S E R V I C E N O T E

HP 8566A AND 8566B SPECTRUM ANALYZER

REPLACEMENT RF ATTENUATOR RETROFIT KIT WITH CALIBRATION PROM

Figure 5. HP 85660A/B RF Attenuator Connections

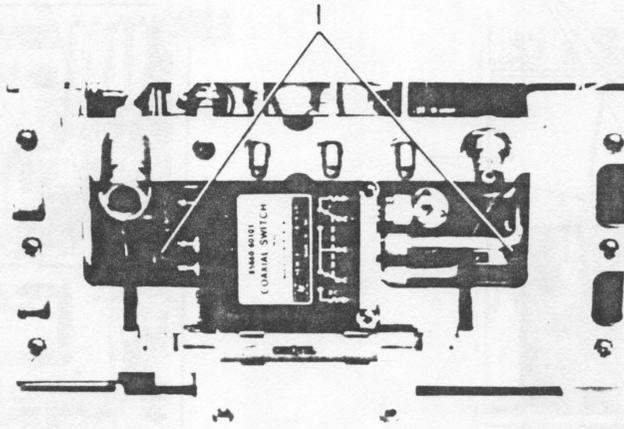
- e. Carefully align both A6A2 RF Attenuator SMA connectors with semi-rigid cables (I), Figure 5, and tighten cables using 6 in-lbs. of torque.
- f. Tighten remaining ends of both semi-rigid cables using 10 in-lbs. of torque.

- j. Carefully align both A6A2 RF Attenuator SMA connectors with semi-rigid cable (I), Figure 5 and tighten cables using 6 in-lbs. or torque.
 - k. Tighten remaining ends of both semi-rigid cables using 10 in-lbs. of torque.

Figure 10. A6A13J5 RF Attenuator Cable Socket, Partial Component Locations

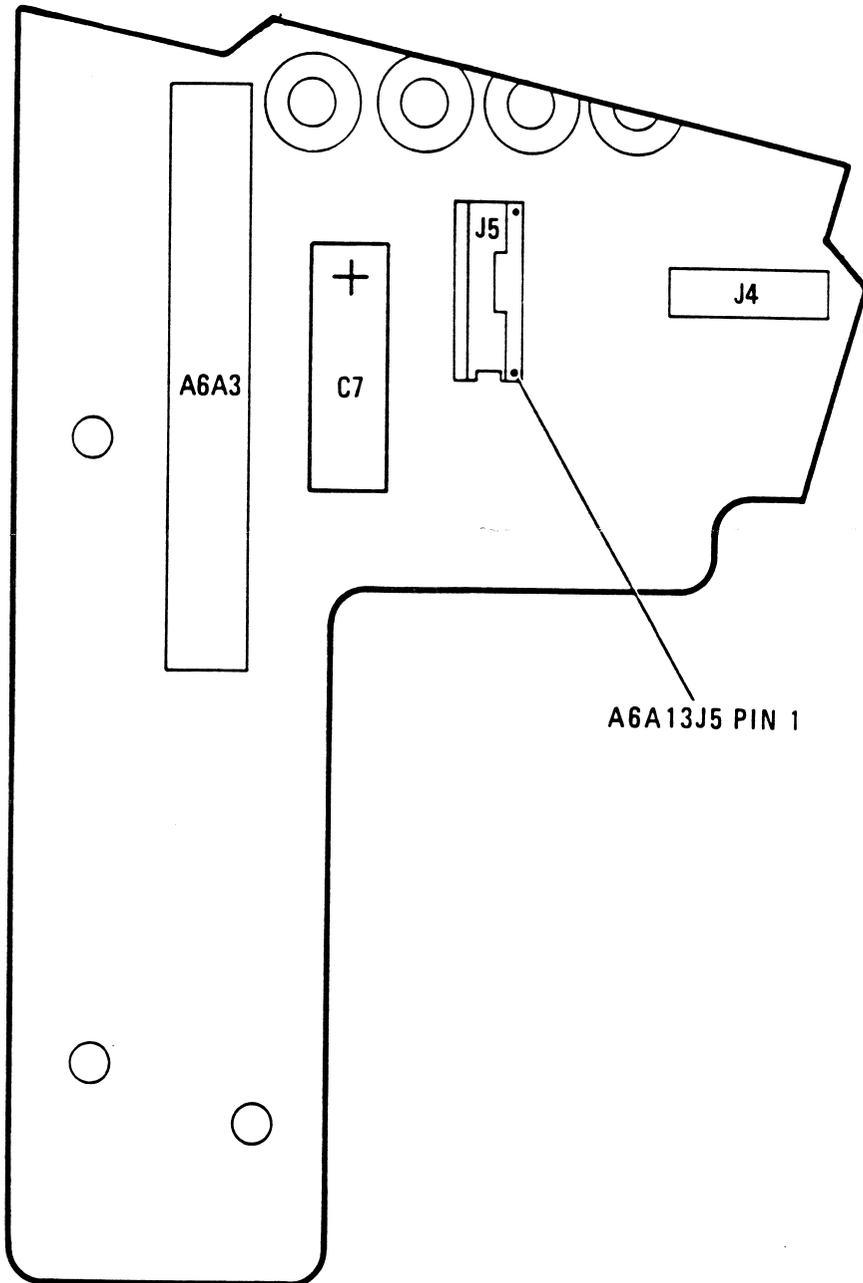
- i. Noting proper plug orientation, plug new A6A2W1 RF Attenuator Ribbon Cable into DIP socket A6A13J5 on RF Module Motherboard (Figure 10). Cable will route towards

A6A3 Last Converter Assembly (away from center of RF Section chassis) when correctly installed with pin 1 aligned with corresponding A6A13J5 pin 1 position.

Figure 11. A6A10 Miscellaneous Bias/Relay Driver, Component Locations

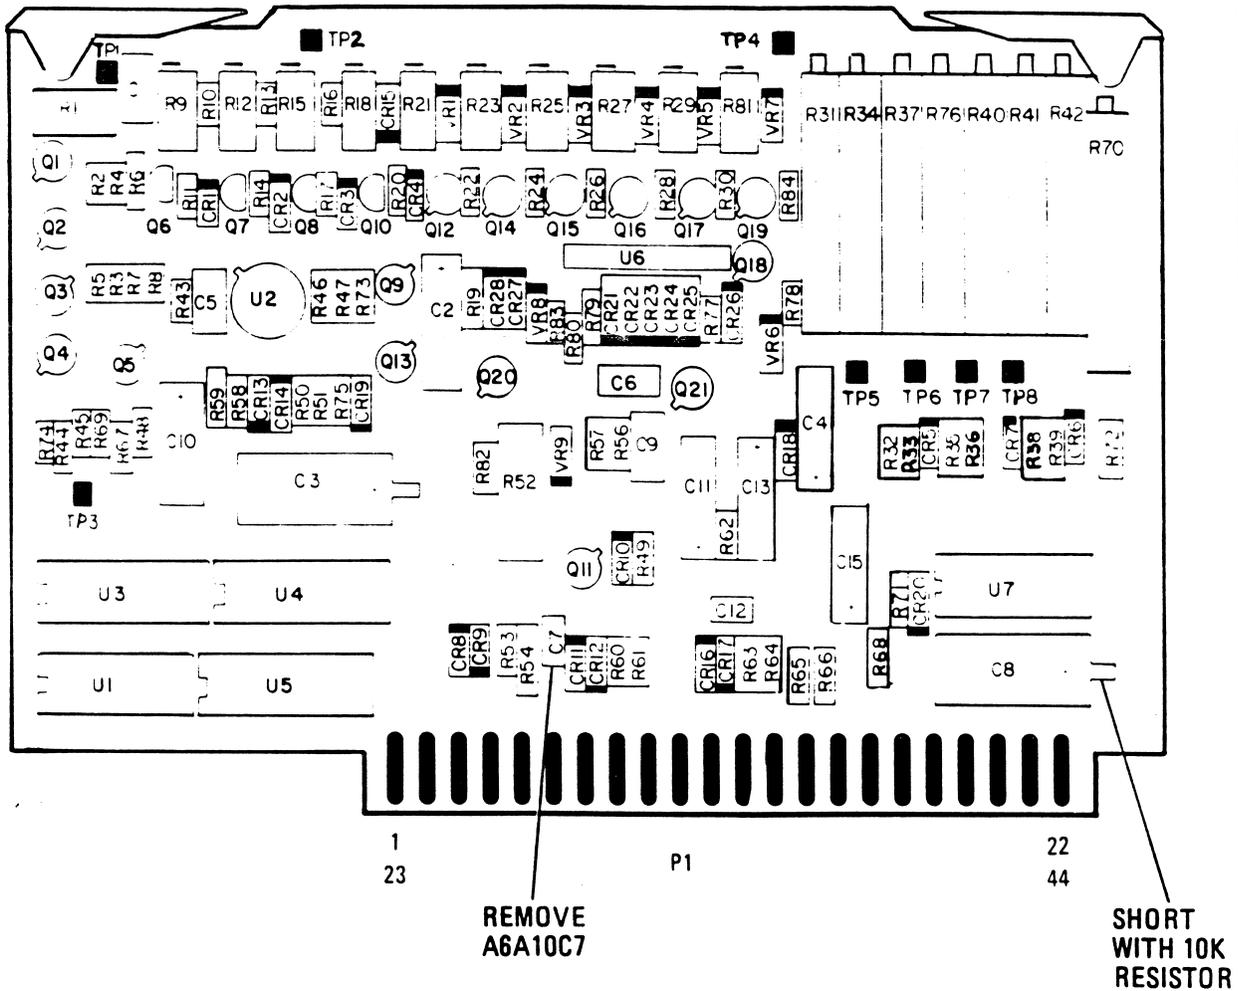
- b. Remove A6A10 Miscellaneous Bias/Relay Driver Assembly from RF Section. Using 10K resistor included in RF Attenuator Retrofit Kit, momentarily short leads of capacitor A6A10C8 (Figure 11) to drain off residual +22 Vdc charge before setting assembly aside.

- l. Replace A6A9 Phase Lock Assembly in RF Section.
 - m. As shown in Figure 11, remove and discard capacitor A6A10C7 (HP Part Number 0160-3879, CAPACITOR-FXD .01 uF 100 VDC CER) from A6A10 Miscellaneous Bias/Relay Driver Assembly.

Figure 12. Proper Installation of A6A10C16, Partial Component Locations - Trace Side

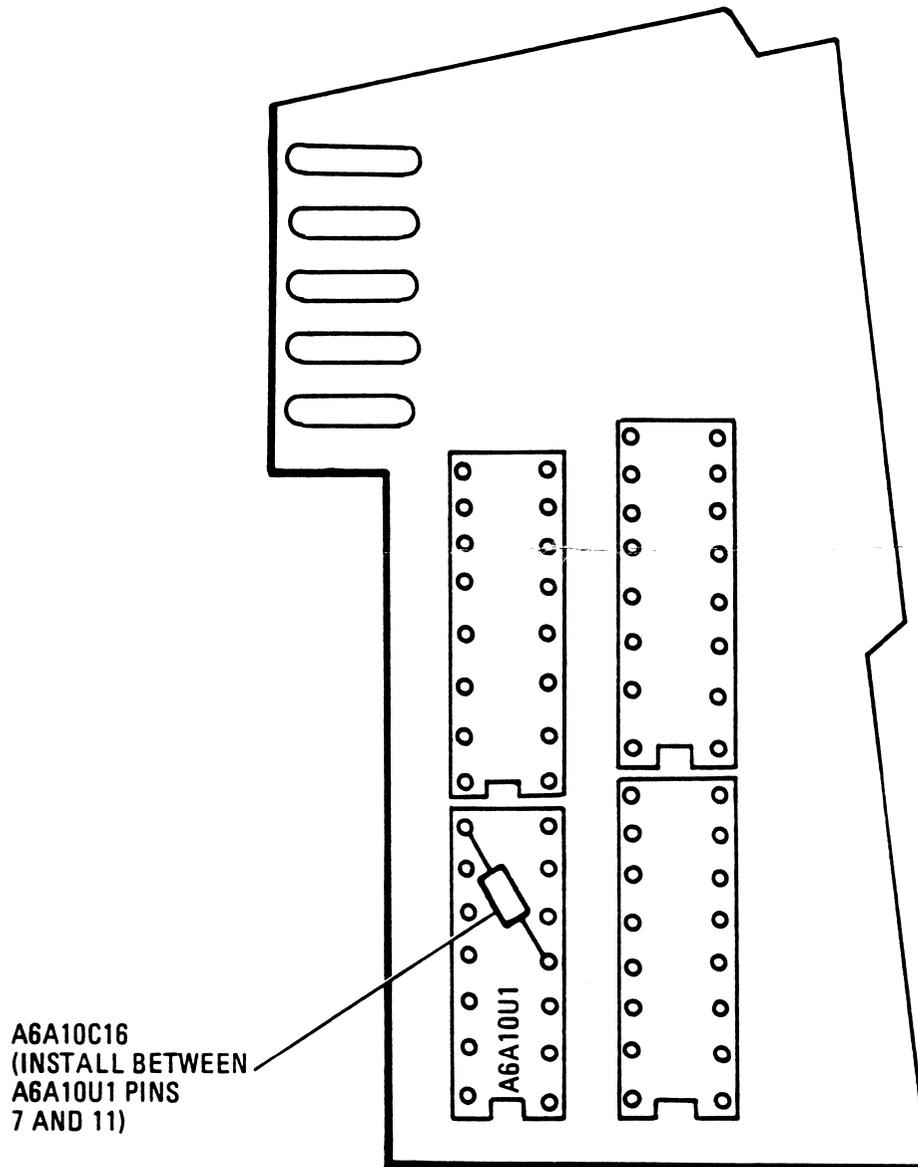
- n. Carefully remove solder from around pins 7 and 11 of A6A10U1 (HP Part Number 1820-1538, IC GATE CMOS NAND QUAD 2-INP). As shown in Figure 12, clip and dress leads of capacitor A6A10C16 supplied in Retrofit Kit (HP Part Number 0160-3878, CAPACITOR-FXD .001 uF 100 VDC CER) and install between pins 7 and 11 of A6A10U1. Make sure that capacitor lies flat against board and does not short other signal traces.

Figure 13. Proper Installation of A6A10R85, Partial Component Locations - Component Side

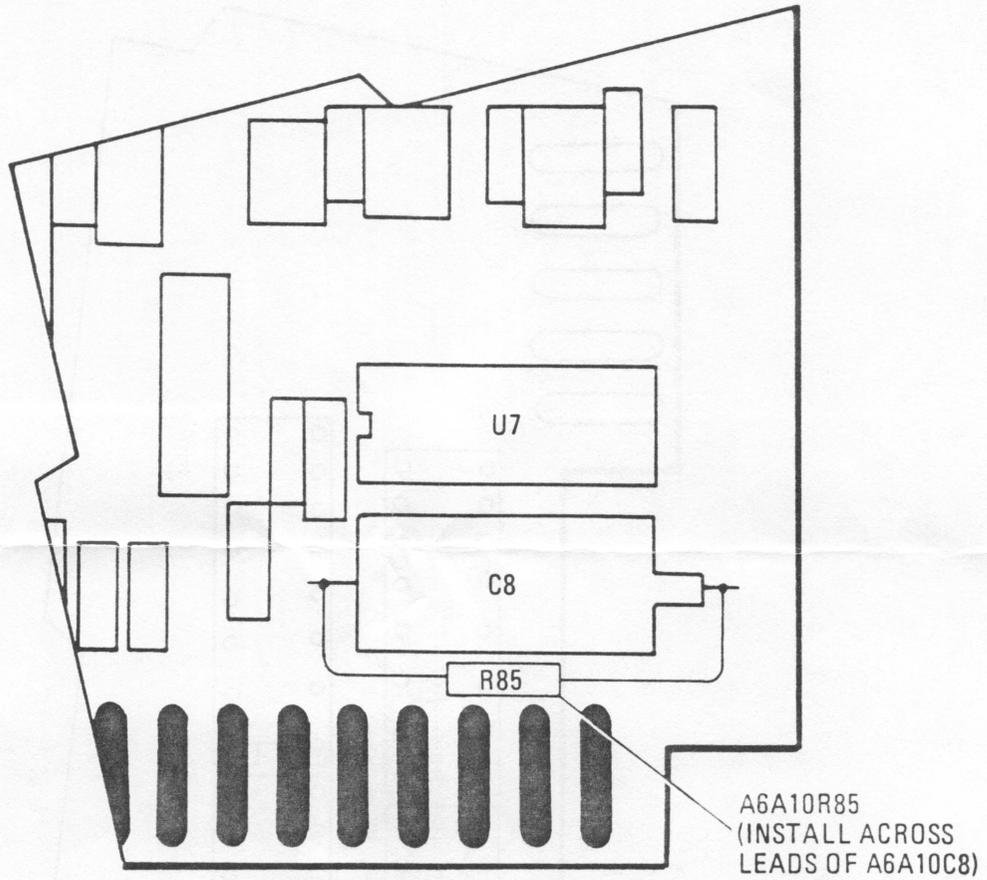
- o. As shown in Figure 13, clip and dress leads of resistor A6A10R85 supplied in Retrofit Kit (HP Part Number 0698-7260, RESISTOR 10K 1% .05W F) and install across leads of capacitor A6A10C8 (HP Part Number 0180-0097, CAPACITOR-FXD 47 uF 35 VDC TA), using heat-shrink tubing as necessary to ensure that resistor does not short to traces on board. Resistor A6A10R85 provides a bleed-down path for residual charge on +22 Vdc filter capacitor A6A10C8, which prevents possible circuitry damage during any subsequent A6A10 Miscellaneous Bias/Relay Driver Assembly troubleshooting or repair.

Figure 14. A12 Front-Panel Interface, Component Locations

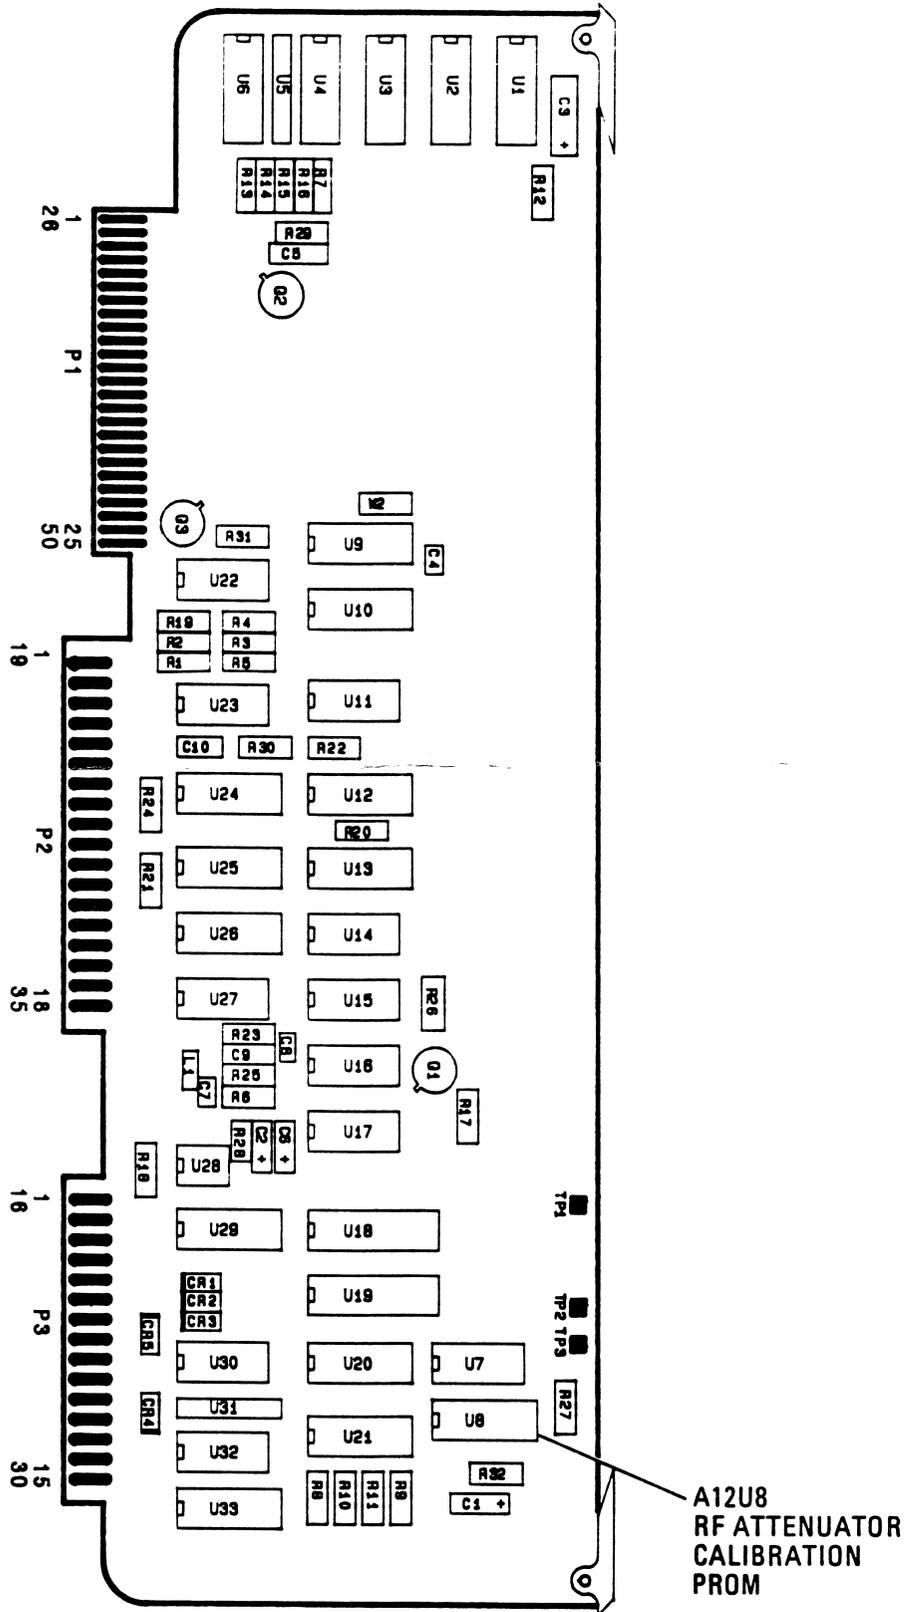
19. Carefully install new RF Attenuator Calibration PROM A12U8 into 16-pin DIP socket on A12 Front Panel Interface Assembly Figure 14.
20. Replace A12 Front Panel Interface into A23 RF Motherboard circuit board position designated by red circuit board guide.
